GENERAL SUMMARY

SUM-77 / 277 / 224  
VARIOUS

**CULVERT DETAIL**  
**177 STA. 443+36**

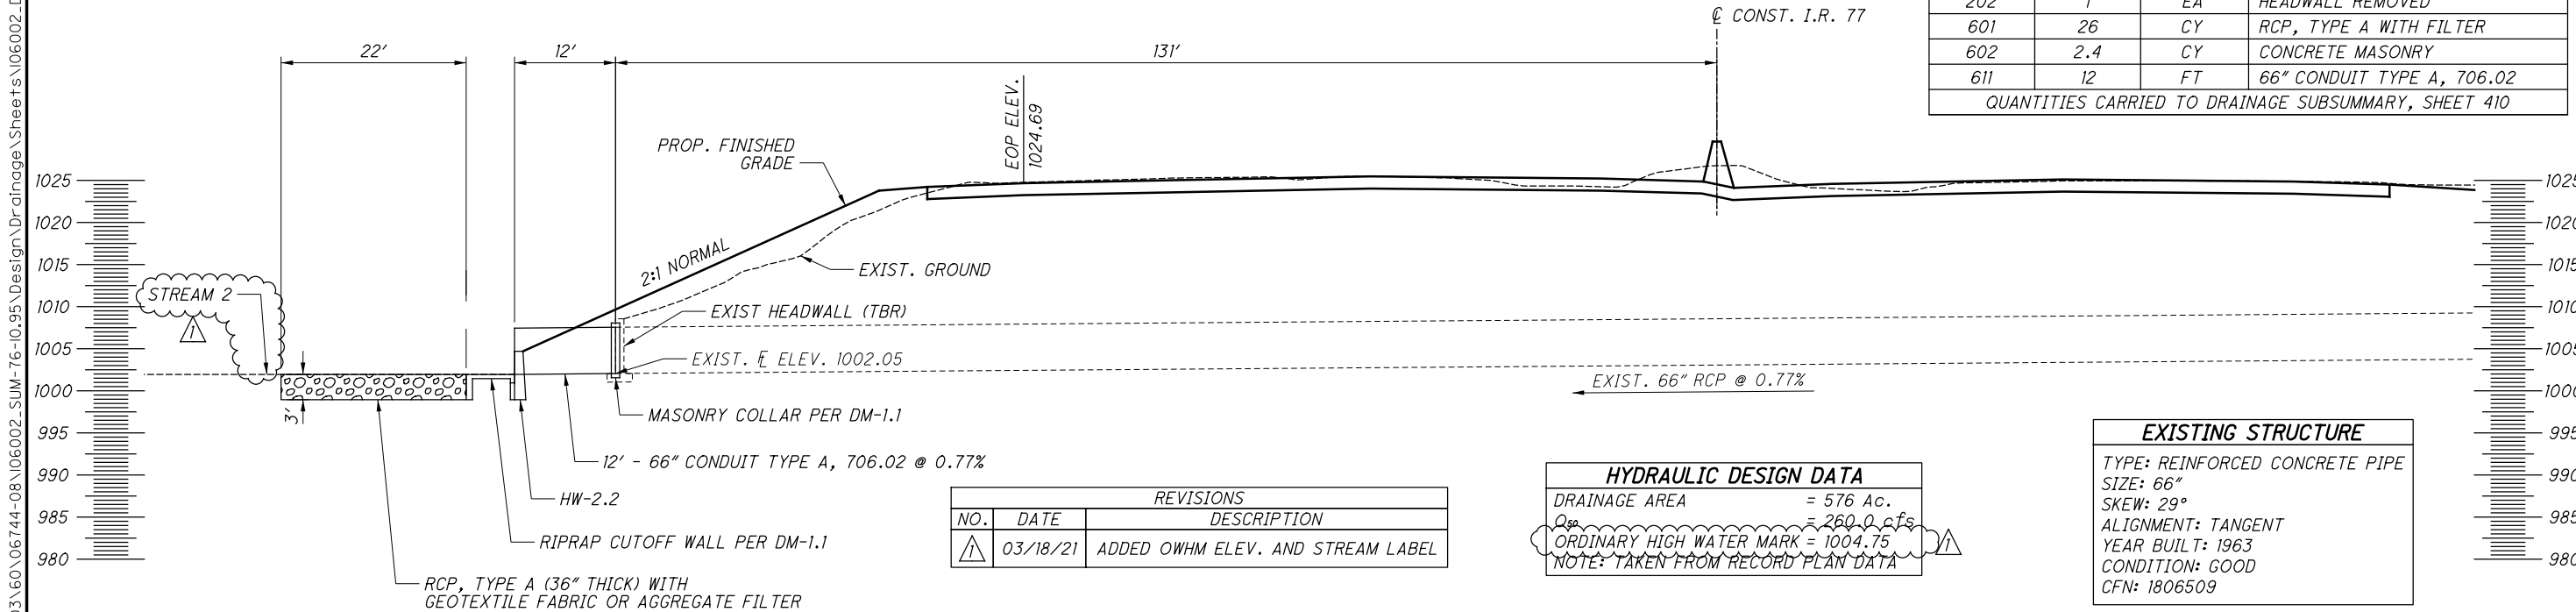
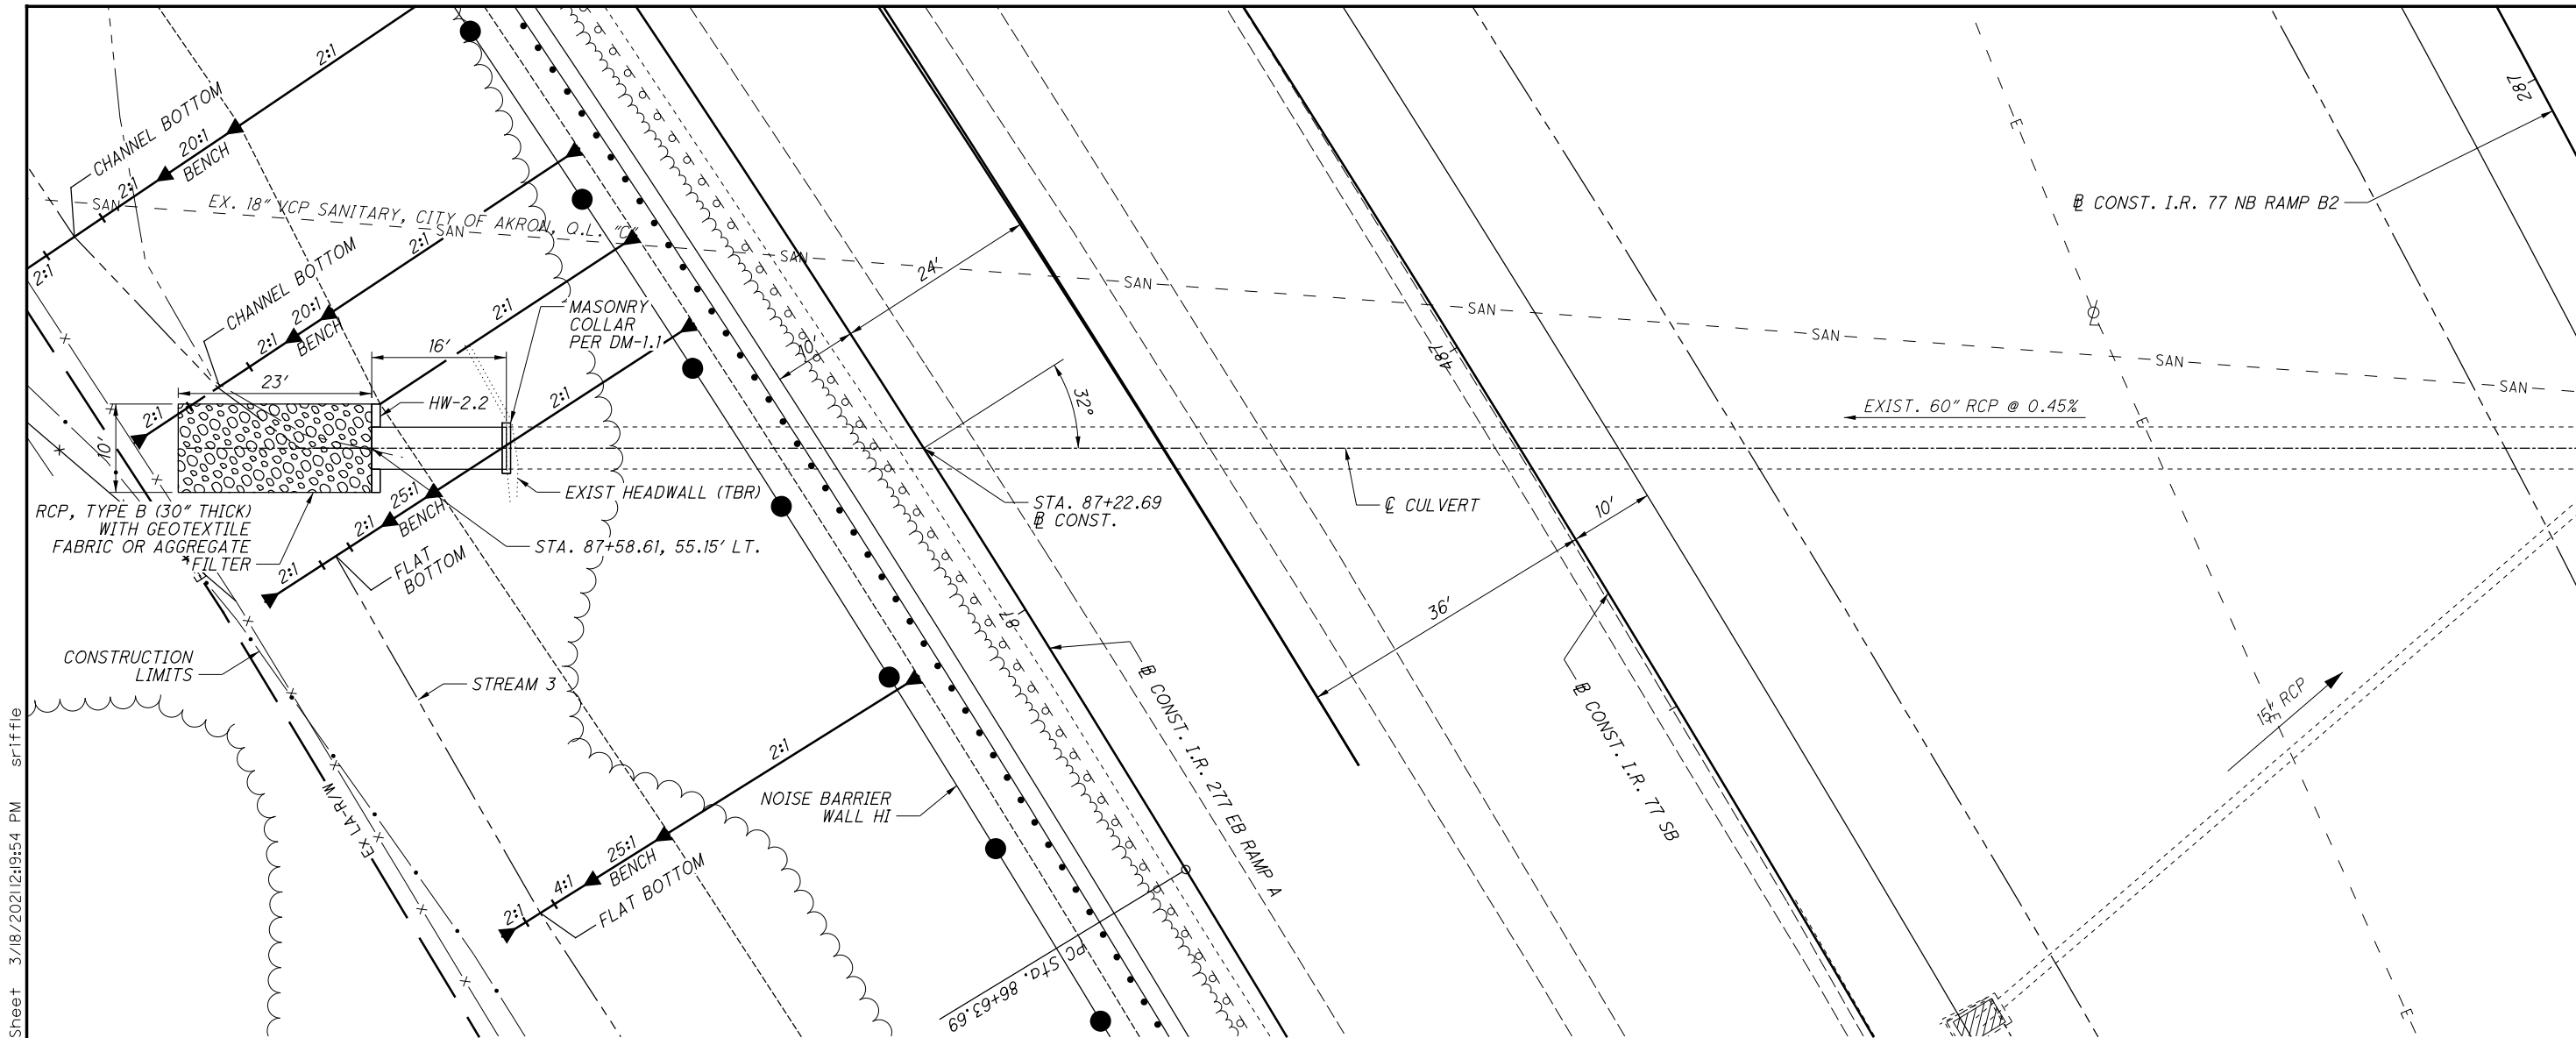
REVISIONS		
NO.	DATE	DESCRIPTION
1	03/18/21	ADDED OWHM ELEV. AND STREAM LABEL

HYDRAULIC DESIGN DATA	
DRAINAGE AREA	= 576 Ac.
$Q_{50}$	= 2600 cfs
ORDINARY HIGH WATER MARK	= 1004.75
NOTE: TAKEN FROM RECORD PLAN DATA

908  
1288

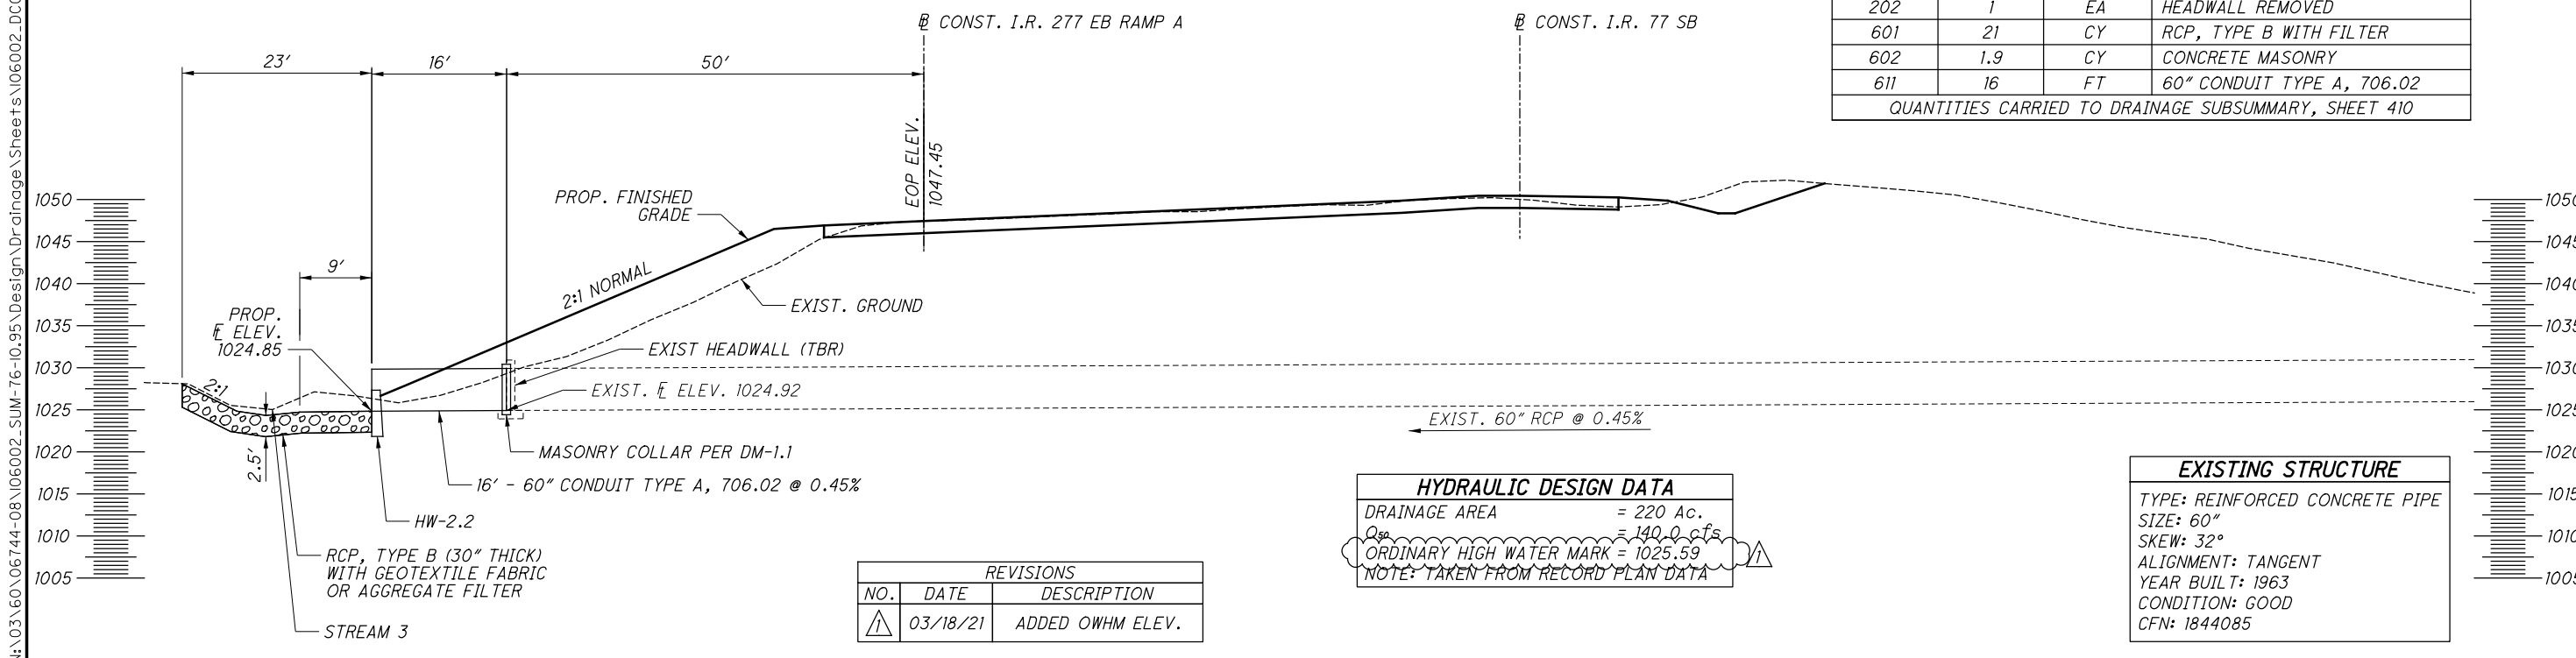
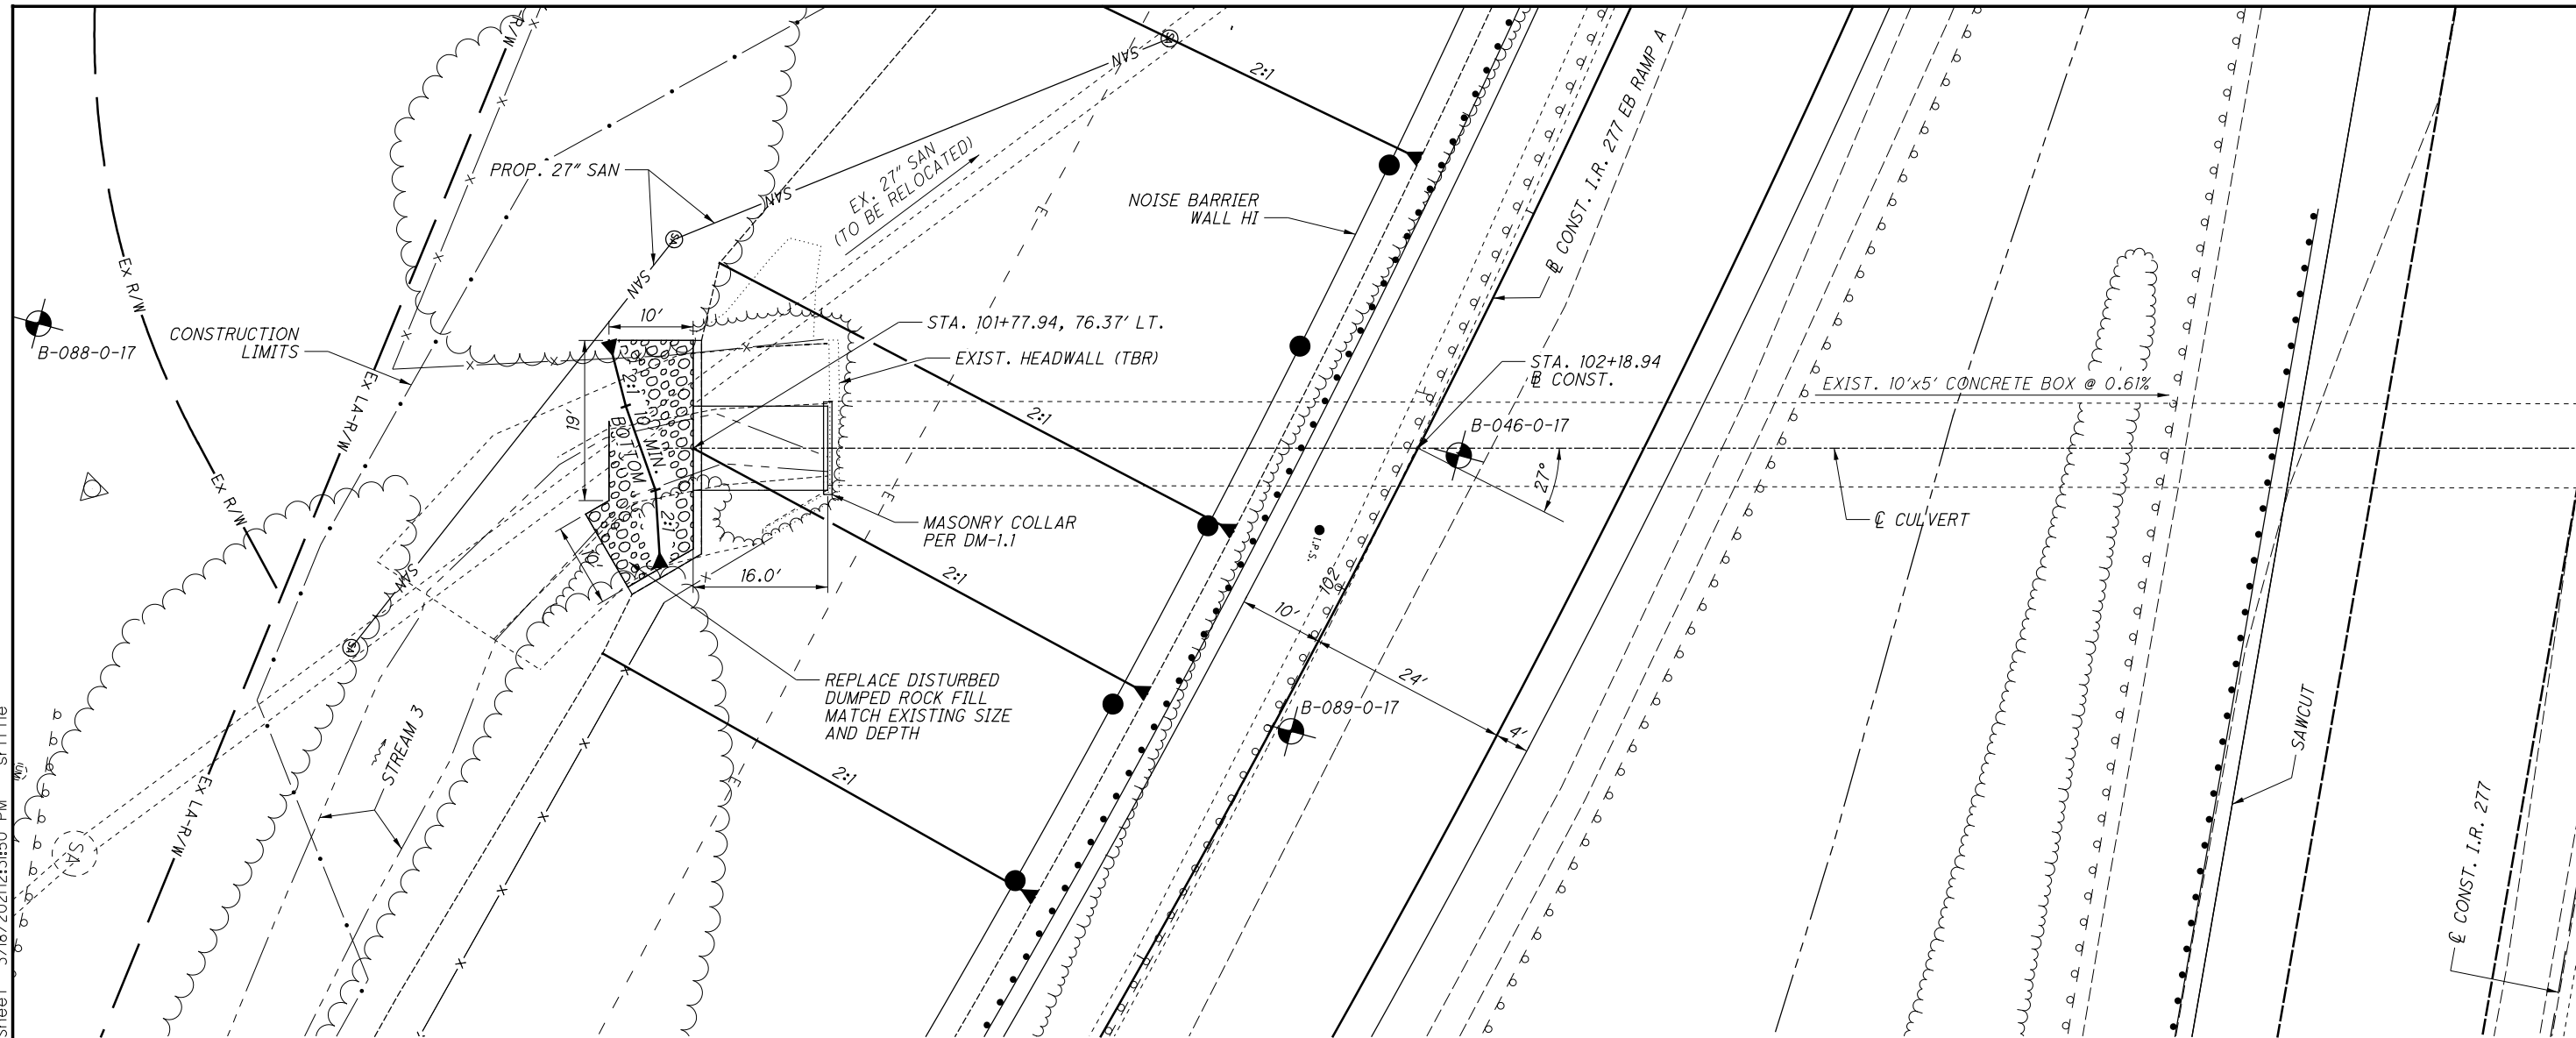
REVISIONS		
NO.	DATE	DESCRIPTION
1	03/18/21	ADDED OWHM ELEV.

HYDRAULIC DESIGN DATA	
DRAINAGE AREA	= 220 Ac.
$Q_{50}$	= 140.0 cfs
ORDINARY HIGH WATER MARK	= 1025.59
NOTE: TAKEN FROM RECORD PLAN DATA
